**STAFF RECOMMENDATION**  
**1911 Boscobel Street**  
**February 20, 2019**

**Application:** Demolition—Partial; New Construction—Addition  
**District:** Lockeland Springs-East End Neighborhood Conservation Zoning Overlay  
**Council District:** 06  
**Base Zoning:** R6  
**Map and Parcel Number:** 08314027500  
**Applicant:** Kim Kennedy, Architect  
**Project Lead:** Sean Alexander, sean.alexander@nashville.gov

**Description of Project:** The applicant proposes to demolish an existing rear addition and to construct a new addition to an historic house. The existing addition is wider than the existing house to the left, and the new addition will be wider to the left and right.

SITE PLAN

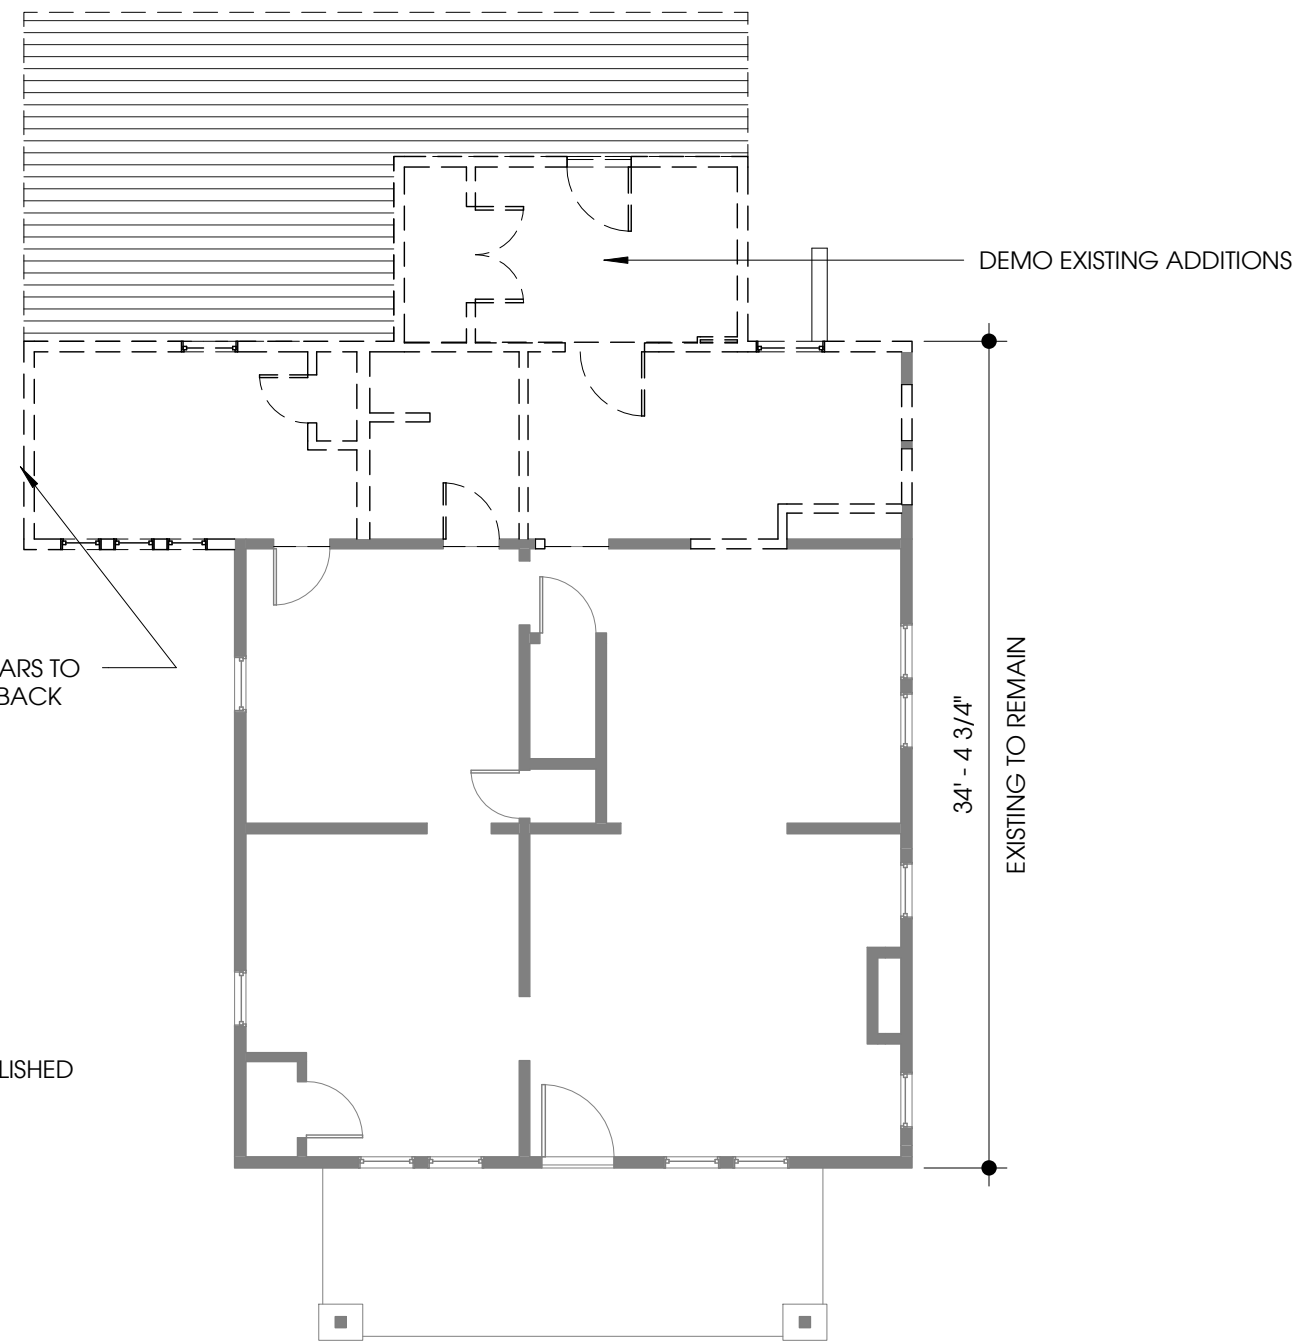
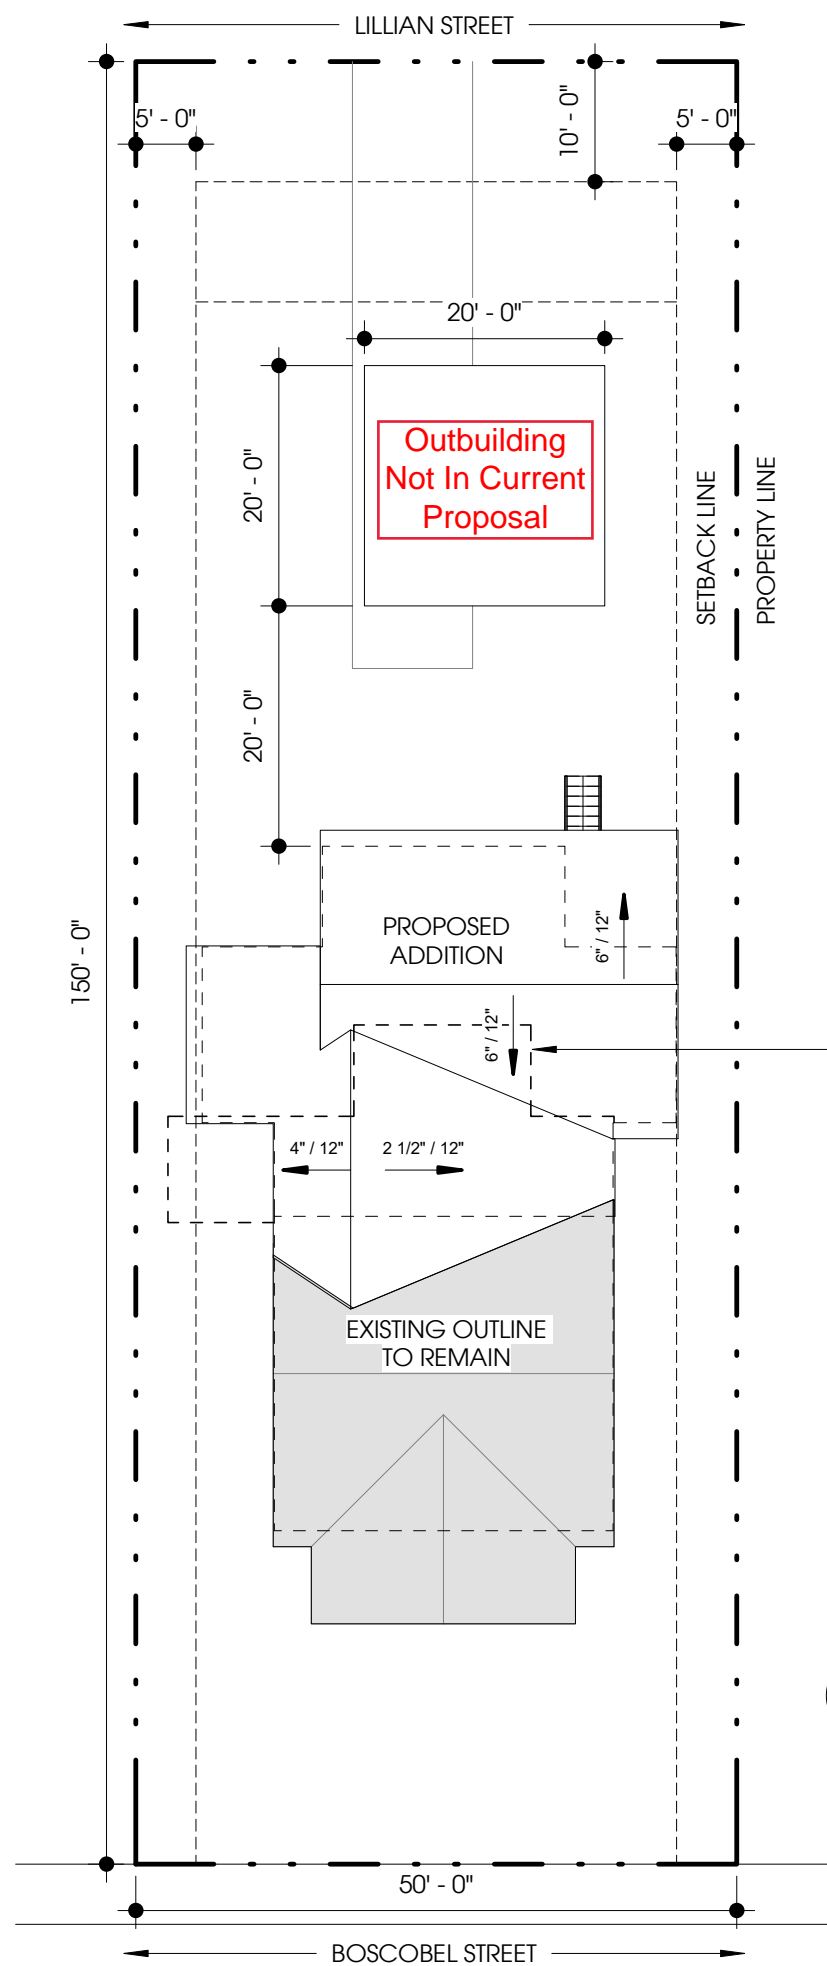
Location & Removability: The addition will attach to the existing house at the rear-left corner where the existing addition is being demolished, and at the right-rear corner. The addition will extend six feet (6') to the left side before going back fourteen feet (14') to the rear. The right side will extend five feet, three inches (5'-3") to the right before going back. Additions should generally be stepped in one foot (1') from each side of an historic house before going back; however staff finds the proposed addition going wider without stepping back to be appropriate because it replaces an existing addition that is not stepped in on the left side and because the addition is minimal and the existing house is small.

Setback & Rhythm of Spacing: The existing rear addition extends nine feet (9') to the left, encroaching approximately two feet (2') into the current required setback of five feet (5'). By reducing the width of the addition to the left with the new proposal, the new addition will meet the setback requirement and result in a more appropriate spacing between 1911 Boscobel Street and the house to the left. The addition to the right side will meet the five foot (5') setback. The adjacent building to the right is noncontributing. For these reasons, Staff finds that the setbacks for the proposed addition will meet section II.B.3 of the design guidelines.

FLOOR PLAN

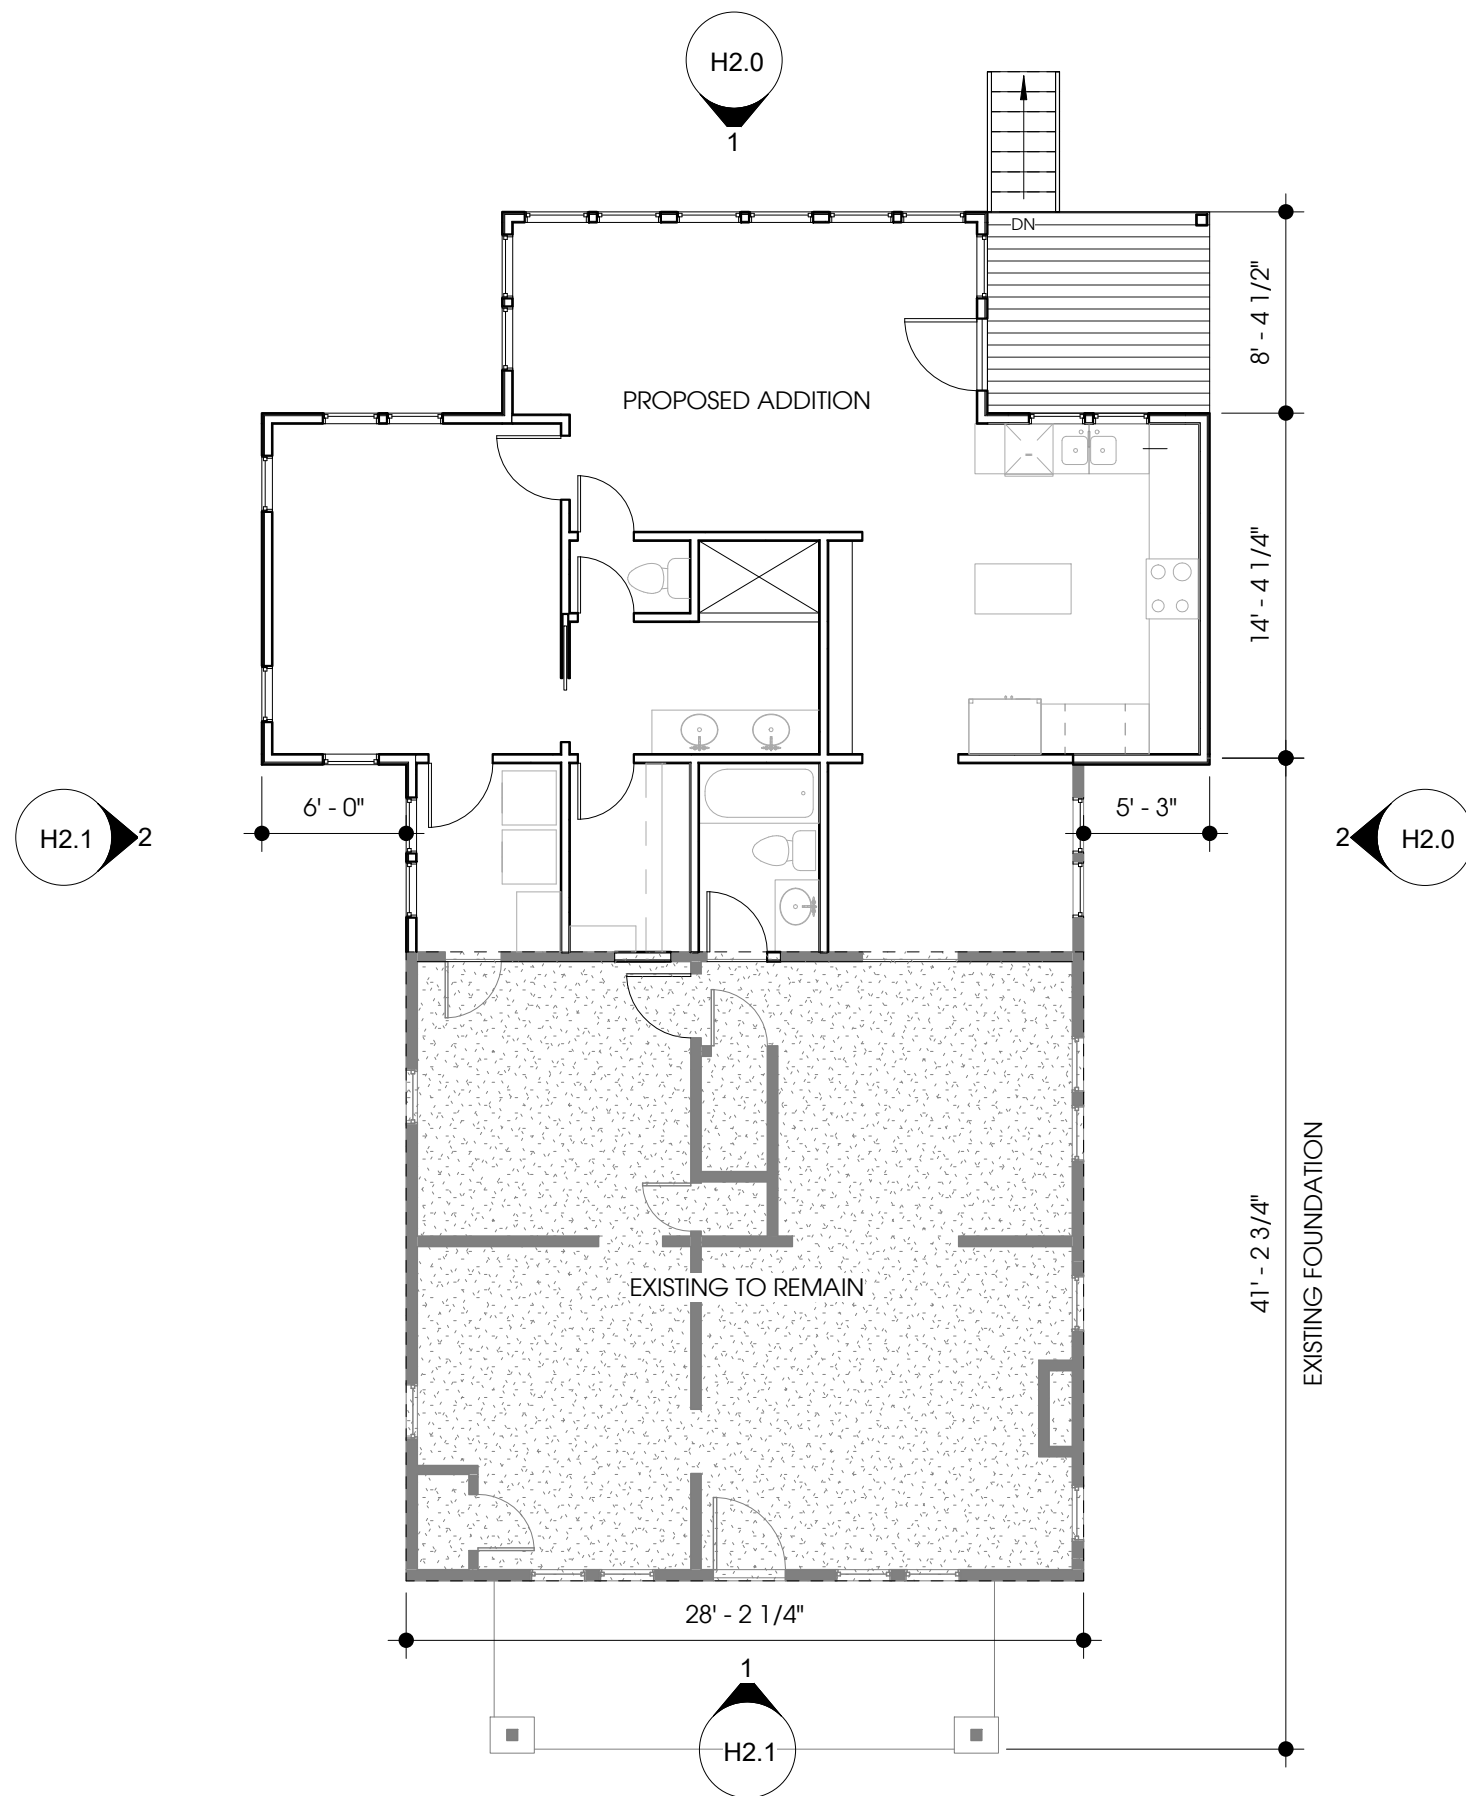
The addition increases the width of the house by five feet, three inches (5'-3") on the right but reduces the width on the left by three feet (3'). The total depth of the addition is twenty-three feet (23'), whereas the depth of the historic house is approximately forty-one feet (41'). Even with the additional width, the amount of new footprint being added is only half of the existing structure's footprint.

ELEVATIONS

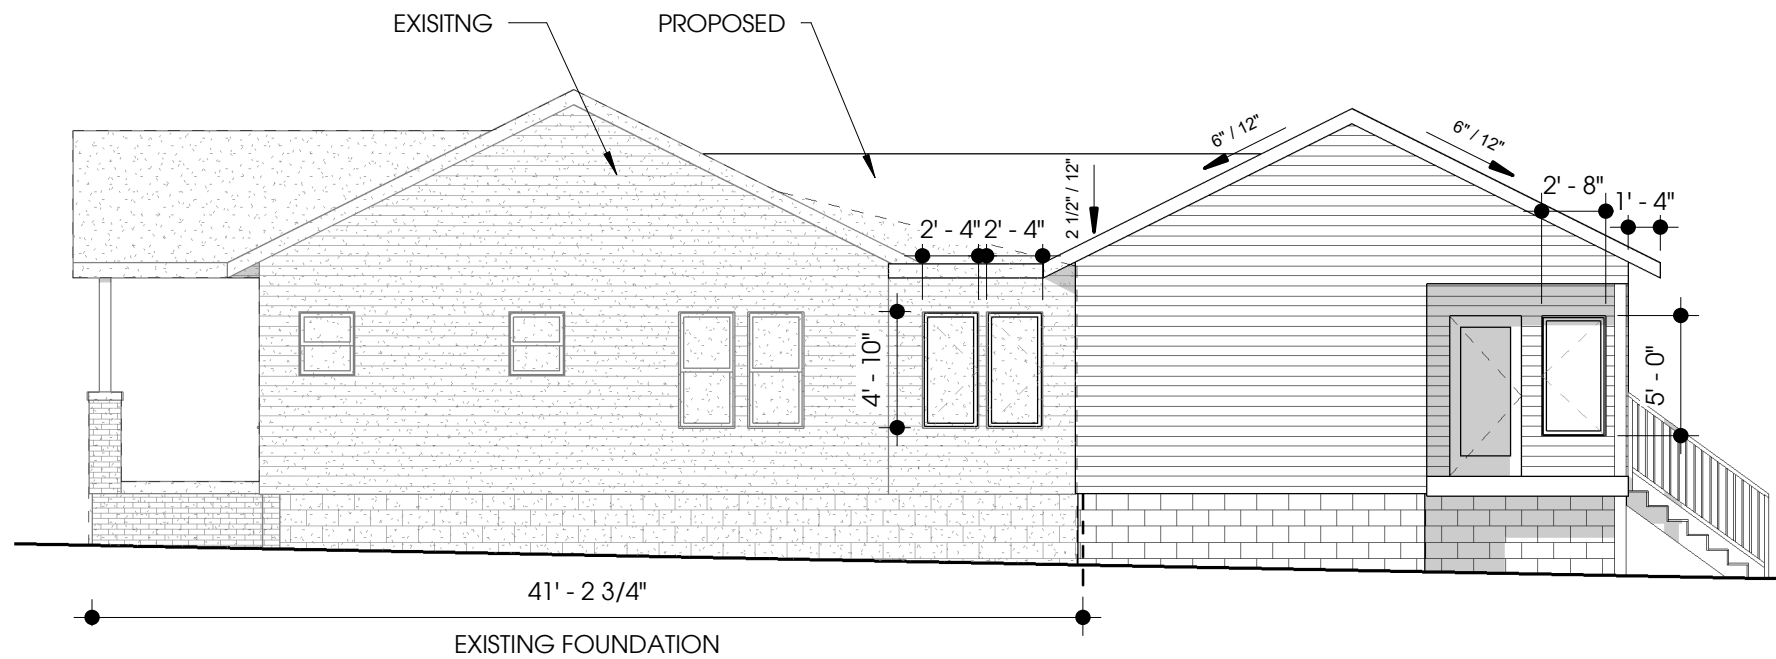
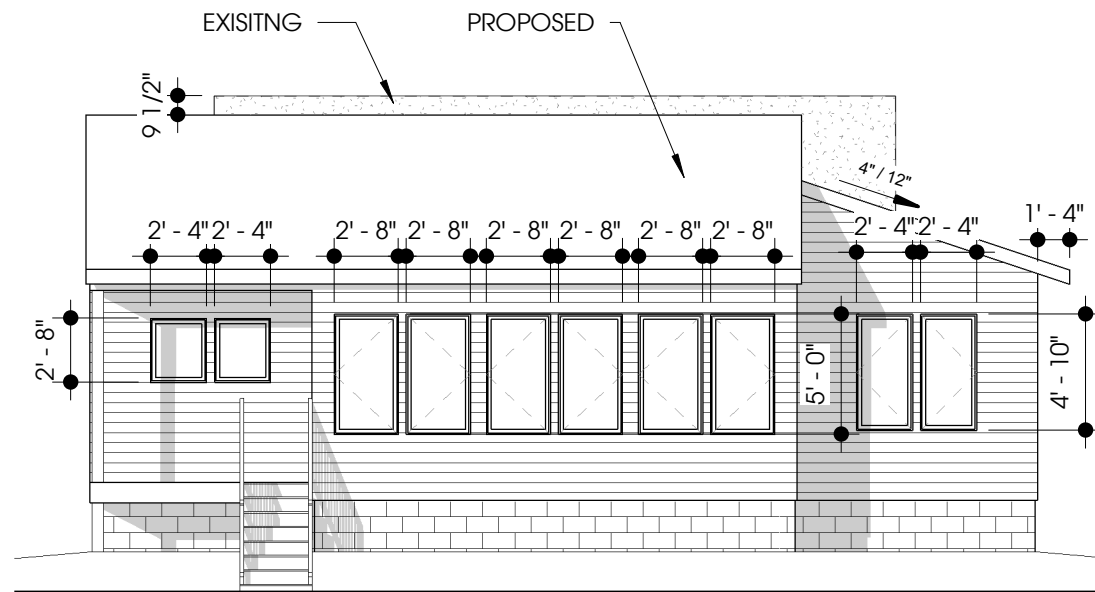
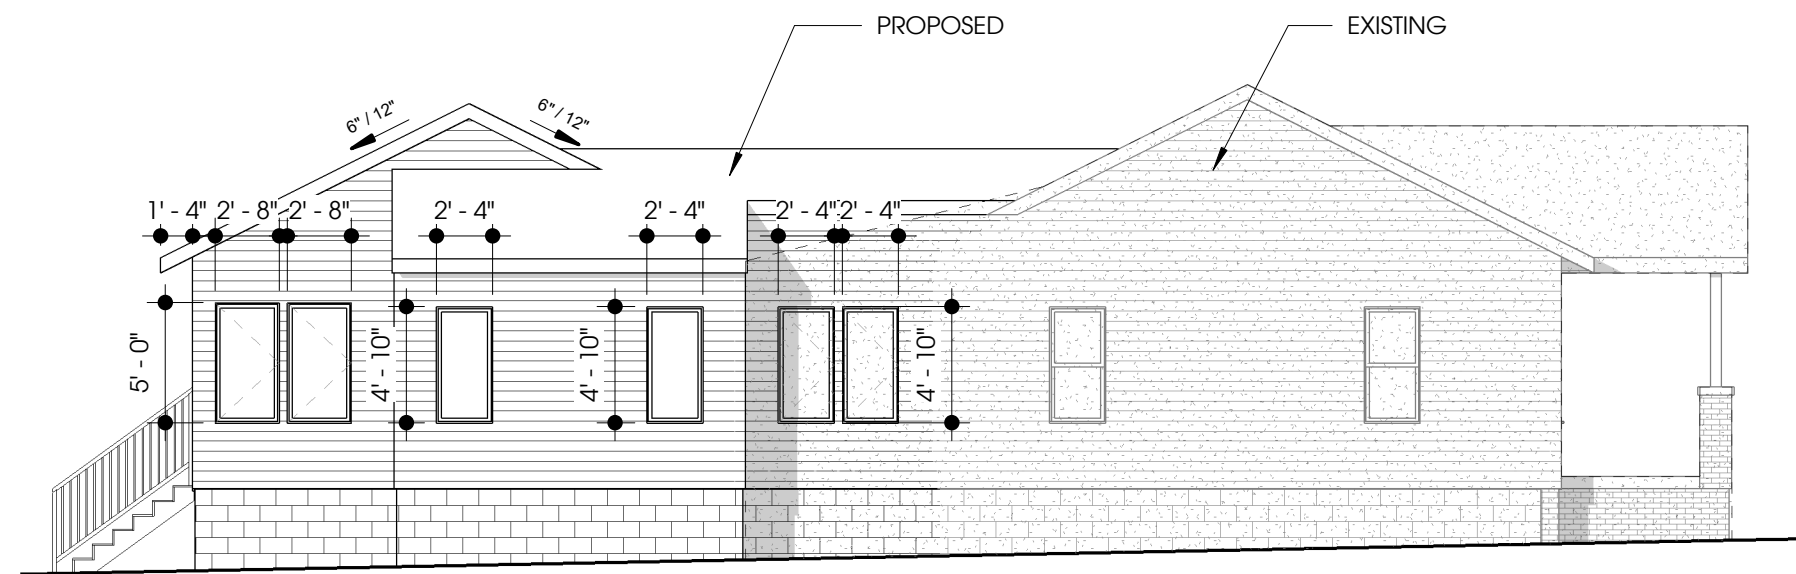
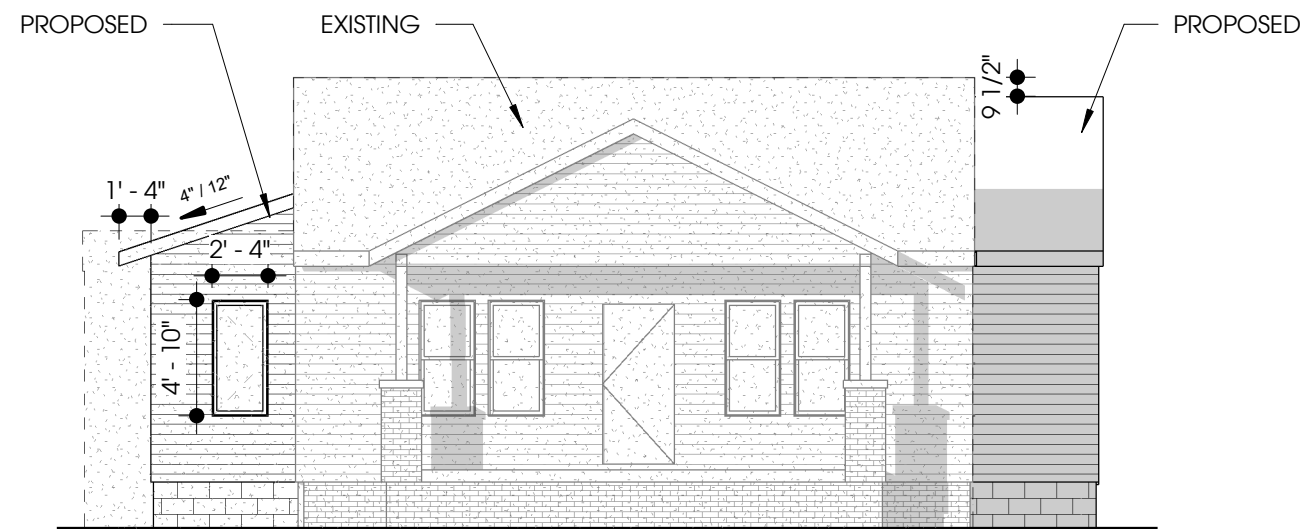
Height & Scale: The addition will have a side-gabled component at the rear, with a ridge height nine inches (9") shorter than the historic house's roof. A lower gabled hyphen will connect the new and existing gables by tying in two feet, nine inches (2'-9") below the existing ridge.

Roof form: The primary roof of the addition will be a side-oriented gable, matching the form and pitch of the existing roof. The roof on the left side addition will be a shed with a pitch of 4:12. These pitches are compatible with the historic house and meet section II.B.5 of the design guidelines.

**Proportion and Rhythm of Openings:** The window openings on the new addition will be vertically oriented openings, arranged in singles and pairs. The sizes and spaces between openings on the left side of the addition are consistent with the openings on the historic house. Staff finds that the window proportions and rhythms are generally compatible with the historic house and that the project will meet section II.B.7 of the design guidelines.

1. A window shall be added on the right side of the addition; and
2. The window selections and roof color shall be approved by MHZC Staff; and
3. The utility connections and HVAC units shall be located behind the midpoint of the building on a non-street facing façade.
